Amendment of Plan to Rezone from “Residential (Group D)” (“R(D)”), “Residential (Group E)” (“R(E)”) and an area shown as ‘Road’ to “Residential (Group C)3) (“R(C)3”) on the Approved Ho Chung Outline Zoning Plan No. S/SK-HC/11 Various Lots in Demarcation District 210 and Demarcation District 244 and Adjoining Government land Ho Chung, Sai Kung, New Territories, Hong Kong

Responses to Comments from Government Departments via Planning Department’s email on 02.02.2024 on the Further Information 03 (FI03) issued on 27.12.2023

Comments from the Acting Director of Drainage Services for Drainage Services Department (DSD) via Planning Department’s email on 02.02.2024; Contact Person: Mr. Henry YEUNG (Tel: 2300 1343)		
<u>Comments on Sewerage and Drainage Impact Appraisal (SDIA)</u>

-	-	07/08/23	Drawn	CN	Date	28/02/2024	Drawing No.
1	Drainage Layout Update	06/11/23	Checked	RT	Approved	RT	Figure 3.4
2	Legend Update	21/12/23	Checked	RT	Approved	RT	
3	Legend Update	28/02/24	Checked	RT	Approved	RT	
Rev	Description	Date	Scale	N.T.S.			Rev.

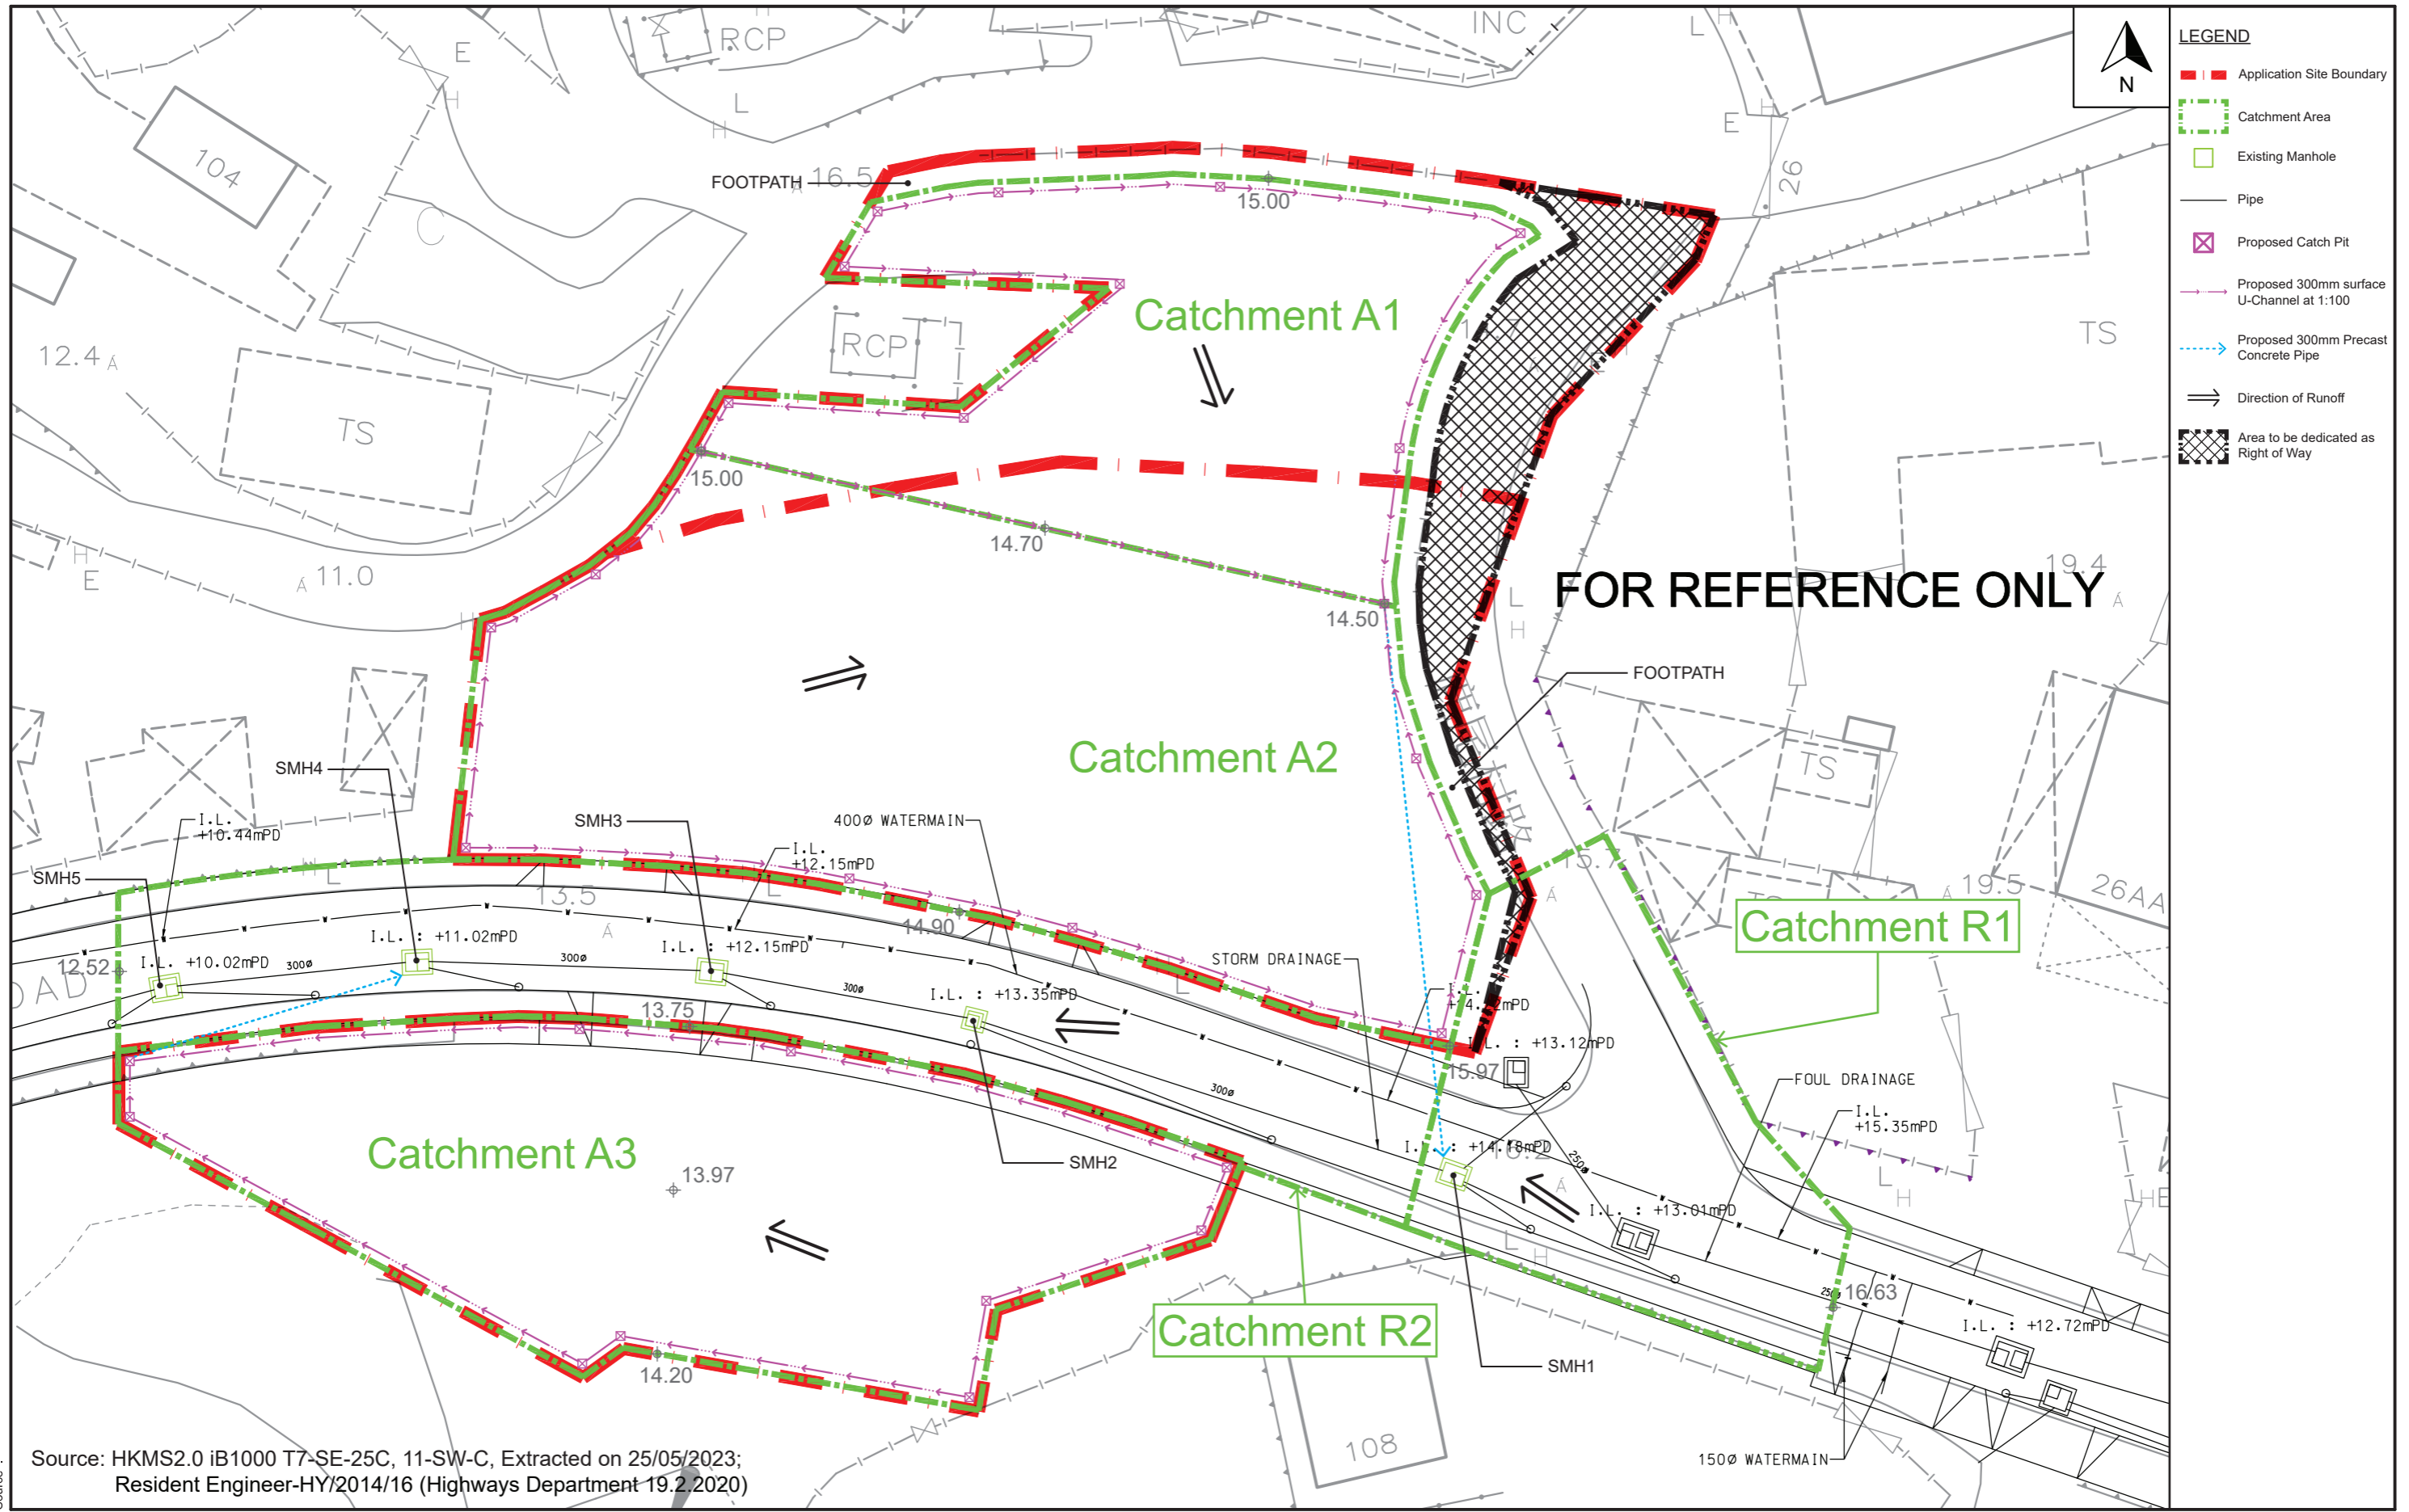
SDIA – DSD2	<p><u>Figure 3.4</u></p> <p>It is noted that the proposed 2 nos of 525mm dia. storm drains will be connected to the existing 300mm dia. storm drains along Ho Chung North Road. Please critically review if such arrangement would cause adverse drainage impact in the vicinity.</p>	<p>The proposed 2 nos. of 525mm dia. storm drains have been amended to 300mm dia. The capacity of the storm drain along Ho Chung North Road has been calculated based on the catchment area of the Proposed Development and Ho Chung North Road. The updated hydraulic calculation is noted that the 300mm drain pipes are considered to be adequate to dissipate all the stormwater accrued by the Proposed Development Site and the said portion of Ho Chung North Road. It has been updated accordingly in the SDIA (Ver. D)). The replacement pages have been enclosed in this RtoC as Attachment 1.</p>

Drawing Title
PHOTOMONTAGE OF VIEWPOINT 1

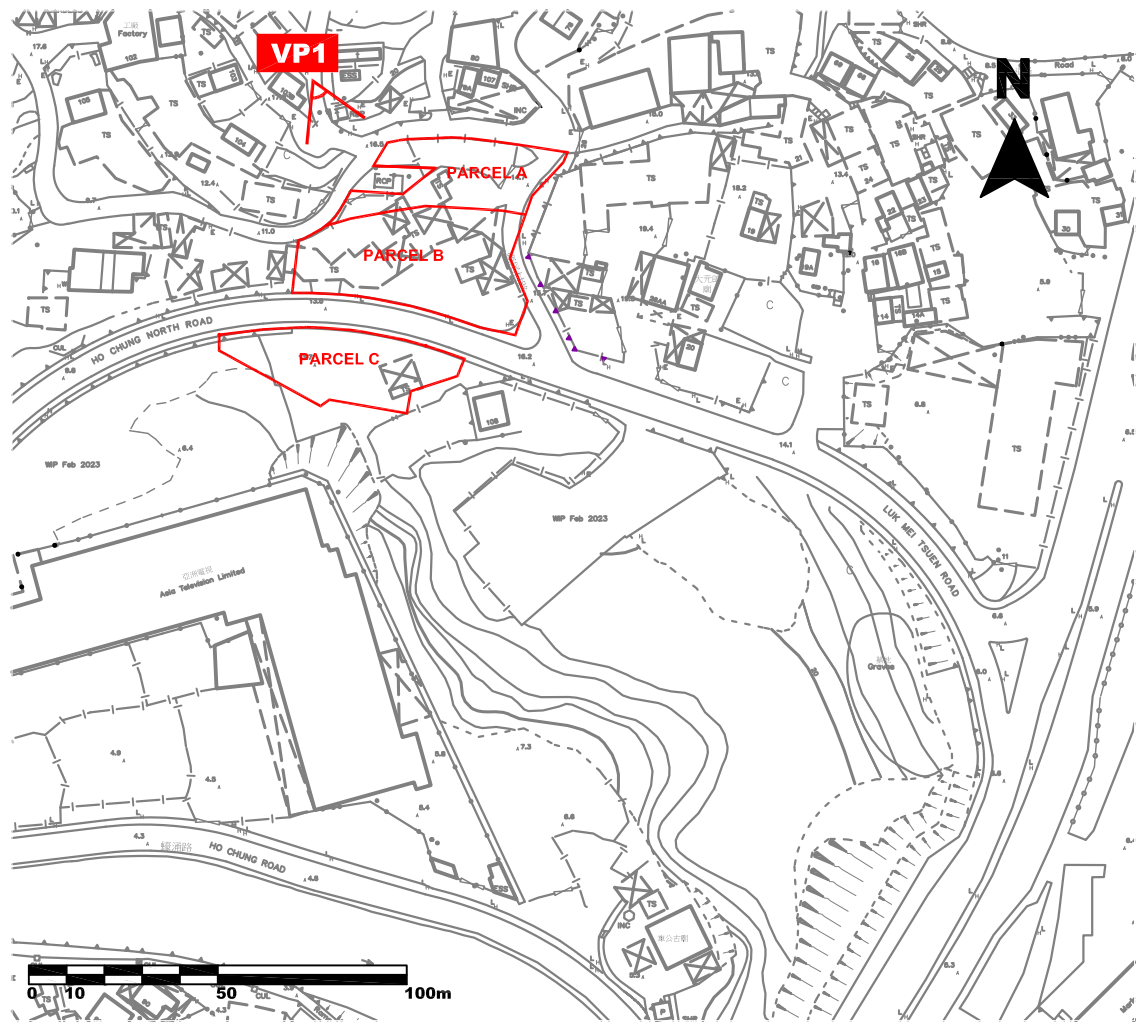
Item	Comments	Responses
VIA – PlanD 1	It appears that the photomontages for the approved scheme (Figures 7.1-7.4) are different from those submitted under previous approved application No. A/SK-HC/326 in terms of building height and number of blocks. Please state clearly the application no. of the previous application as referred to in the photomontages, and critically review the accuracy of the photomontages.	Noted. Instead, the Approved Ho Chung Outline Zoning Plan No. S/SK-HC/11 Compliance Scheme (OZP Compliance Scheme) has been used for comparison. It has been updated accordingly in the Visual Impact Assessment (Version D) (VIA (Ver. D)) and it has been enclosed in this RtoC as Attachment 3 .
